Regarding: 05V-067

Technical BULLETIN

RECALL

All XVS11A, XVS11AT, XVS11, XVS65A, XVS65AT, XVS65, and XV250 FACTORY MODIFICATION CAMPAIGN

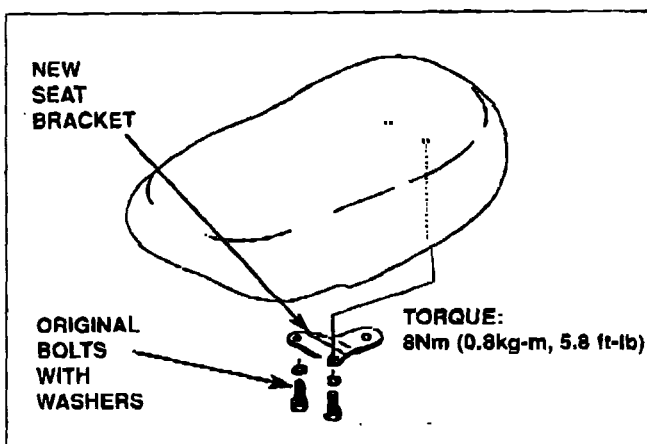
3. Install the new seat bracket from the kit using the original bolts and washers. The new bracket has a larger hole for the grommet.

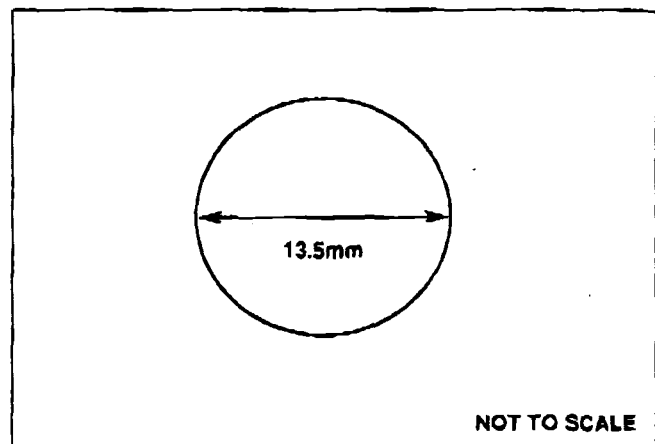
3. Lift the rear fender just enough to access the stud hole. Using a step drill or another appropriate tool, carefully enlarge hole on the rear fender for the passenger seat stud bolt to 13.5mm. Smooth the edges of the hole.

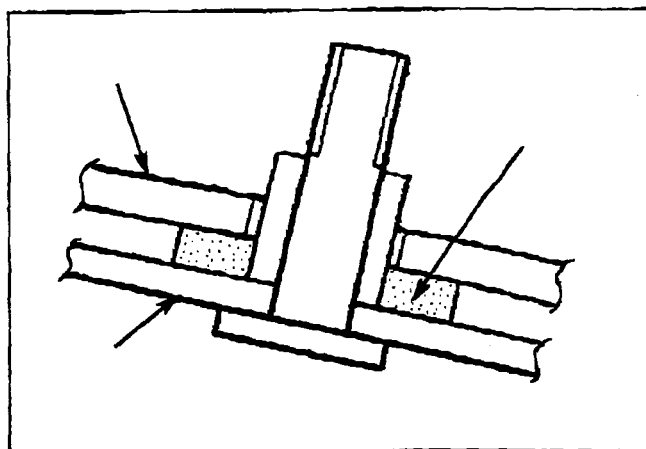
3. Lift the rear fender just enough to have enough space to remove original grommet. Install the new grommet 3 (rubber washer without groove) between rear fender and rear frame through the stud hole.

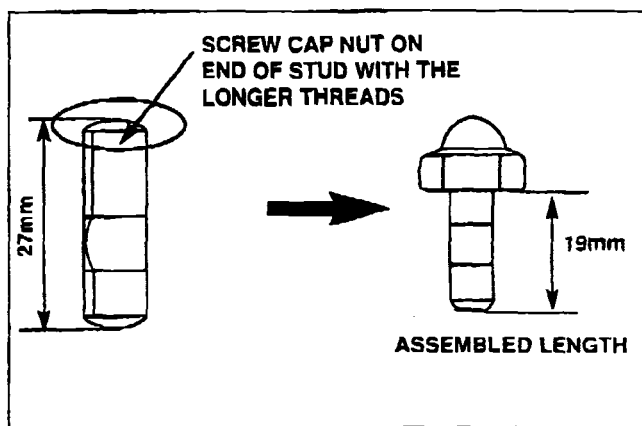
2. Use the shorter bolt from the kit (the 51mm stud is for other markets where a rear seat stay is installed as standard equipment). Hold the stud bolt (stud bolt 1) from the kit at the unthreaded portion. Screw the cap nut onto the end of the stud with the longer threads until the exposed stud is 19mm long.

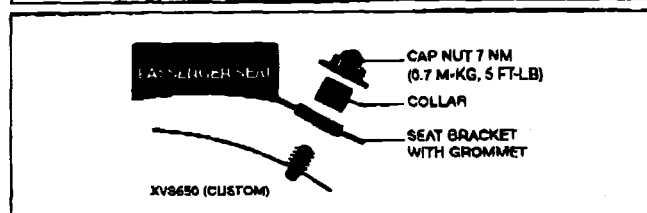
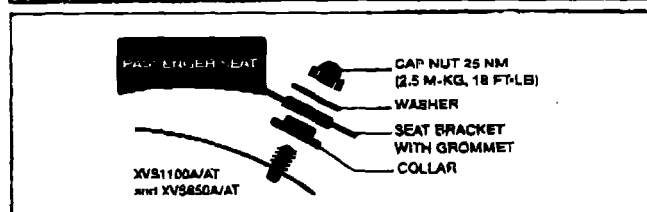
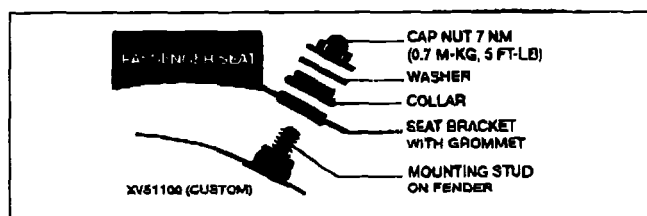
The Owner's Manuals for all V Star models (but not the Virago 250) describe removal and reinstallation of the passenger seat. If you are modifying an unregistered unit, put a sticker for the appropriate model on the page covering the Passenger Seat (check the index in the back if you have trouble locating the right page). Some stickers are enclosed with this bulletin. Contact your RTA if you need more.
